SERVICE BULLETIN

DATE: 10-12-2011 **BULLETIN NO:** 11-005A

TITLE: HYDRAULIC FLUID LEVEL SWITCHES REPLACEMENT

PRODUCT SERIES / MODEL: W96 Series E3-43 / 44 / 45 Top Gun Spikers

**FIGURE 1
HYDRAULIC RESERVOIR**

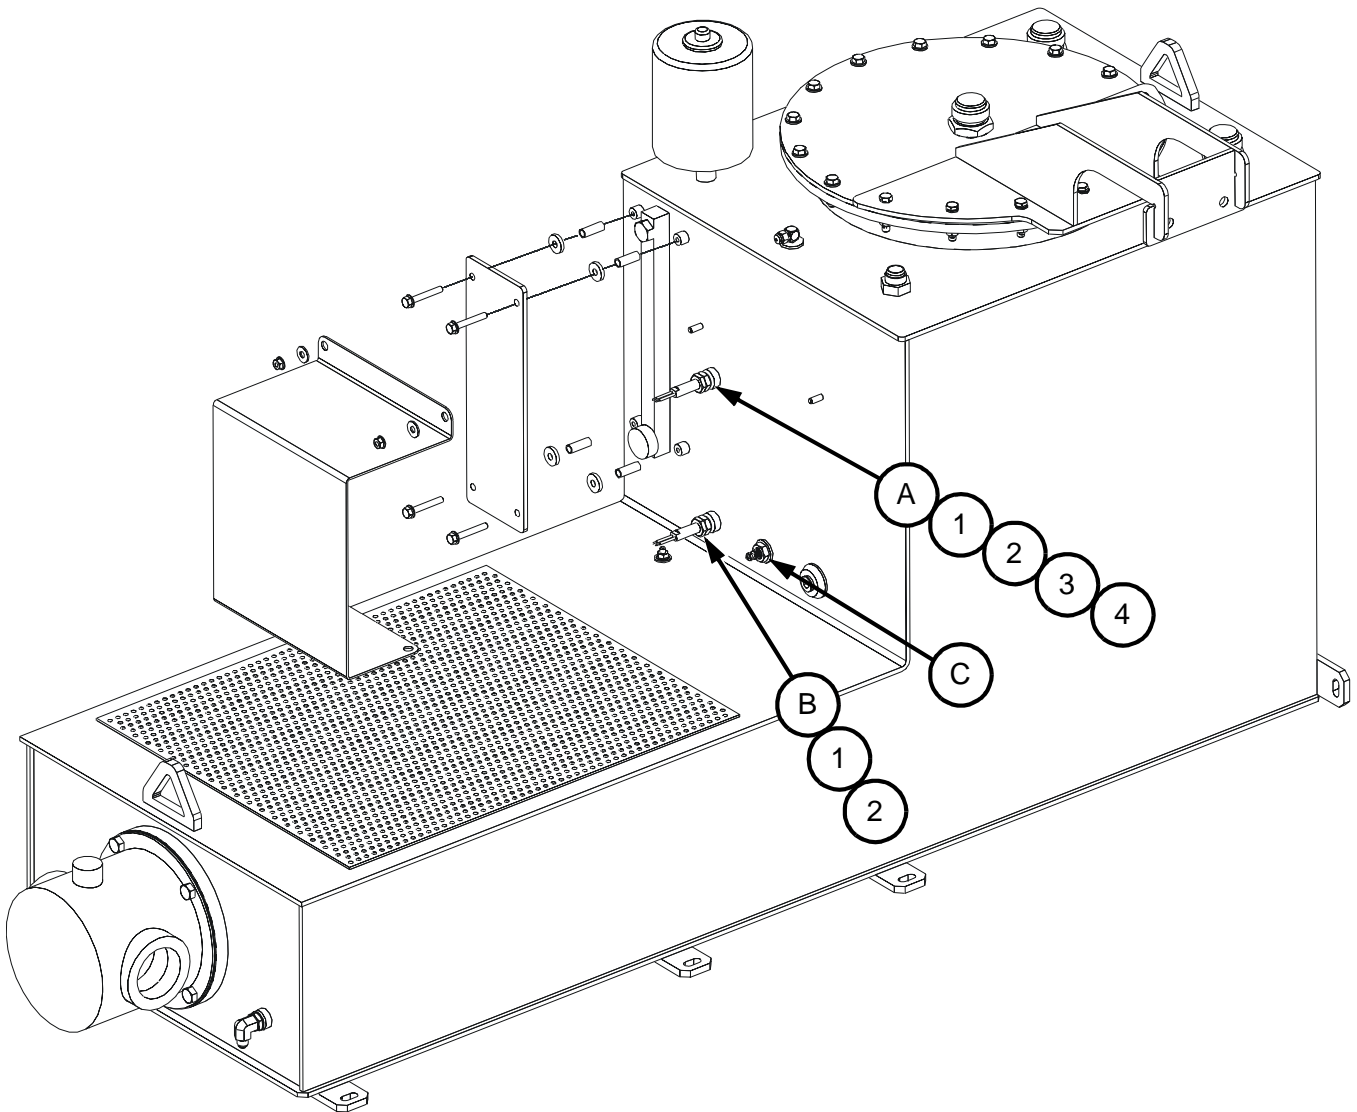
SUMMARY: Coolant level switches (#408516) were installed in the hydraulic reservoir and used for both the low hydraulic fluid level alarm and shutdown systems. These switches will not work in hydraulic fluid and both must be replaced with hydraulic fluid level switches (#416078).

OPERATIONAL IMPACT: Replace both the low hydraulic fluid level alarm and shutdown switches in the hydraulic reservoir. New mounting adapters are also required to install the new switches in the hydraulic reservoir.

1. Locate the low hydraulic fluid level alarm switch (A), low hydraulic fluid level shutdown switch (B) and hydraulic fluid temperature sending unit (C) in the backside of hydraulic reservoir.

3. W96E3-43 Models Only: Disconnect wire cable from shutdown switch (B). Cut wire cable from float switch (A) and from temperature sender (C). Then remove float switch (A), shutdown switch (B) and any adapters from the hydraulic reservoir ports (A - B).

4. W96E3-44 / 45 Models Only: Disconnect wiring harness from alarm switch (A) and from shutdown switch (B). Then remove alarm switch (A), shutdown switch (B) and any adapters from the hydraulic reservoir ports (A - B).

5. Install two new adapters (2) in the hydraulic reservoir ports (A - B).
6. Apply pipe sealant to pipe threads only and then install two new hydraulic fluid level switches (1) in hydraulic reservoir ports (A - B).

1. Route new wire cable (4) from Engine Junction Box to new alarm switch (1) and existing temperature sender (C) in hydraulic reservoir.
2. In Engine Junction Box, disconnect all wires of existing wire cable S1210 and remove cable. Connect new wire cable (4) wires as follows:

7. In Main Control Box, locate white wire #1212 that connects pin 14 of relay K1210 to TB1-33.
 - a. Remove wire #1212 from TB1-33.
 - b. Change wire label #1212 to #412.
 - c. Re-connect wire #412 to any unused terminal of TB1-30 or 31.

1. Reconnect existing wire cable to alarm switch (1) and shutdown switch (1) in hydraulic reservoir ports (A - B).
2. In Main Control Box, remove black wire from TB1-37 that is in CTRL-CPU cable. There are two black wires on TB1-37, so you will need to trace the wires to determine correct cable.
